The following comments are an in addition to my previous Objection.

Arup's report (Appendix O) shows the following graph (page 24):

The report also shows the following image (page 25):

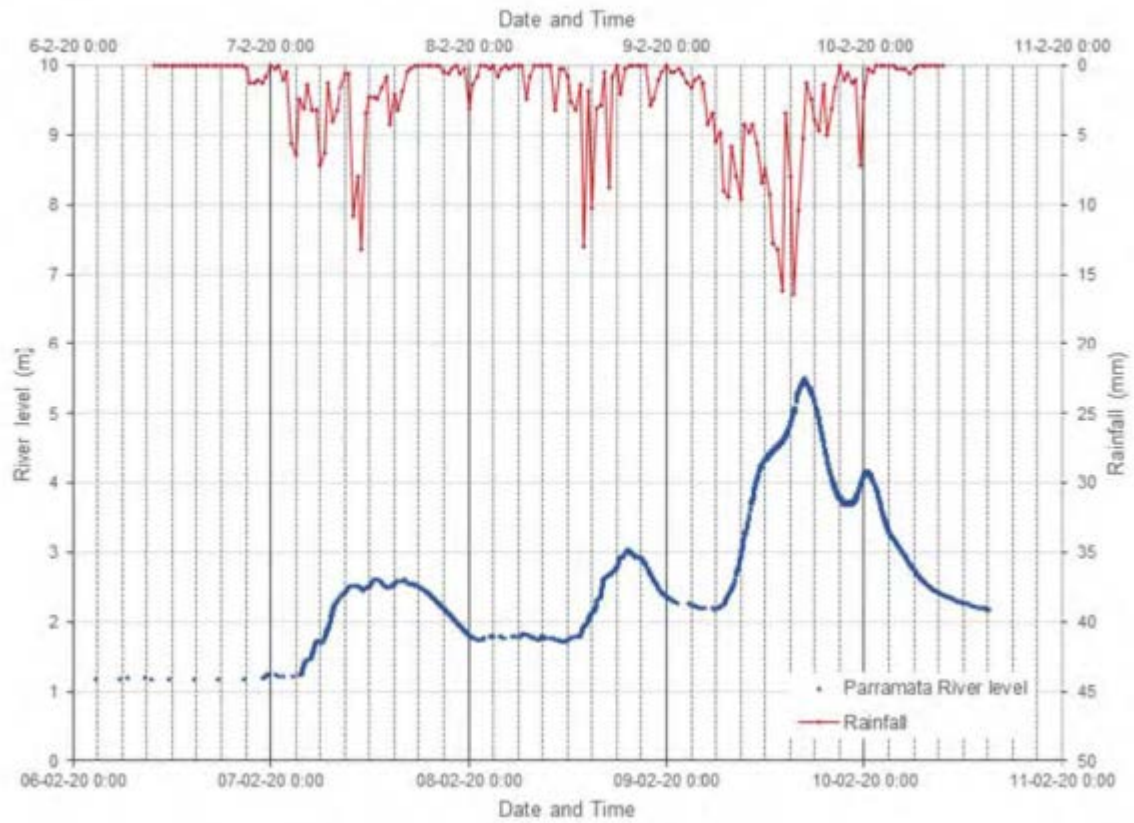
This image was provided to the SMH and adapted in part for publication. I requested my name not be published.

The image was taken on Sunday 9 February 2020 at 6:38pm, when the river had not reached its peak as indicated by the graph. My copy of the original image is attached.
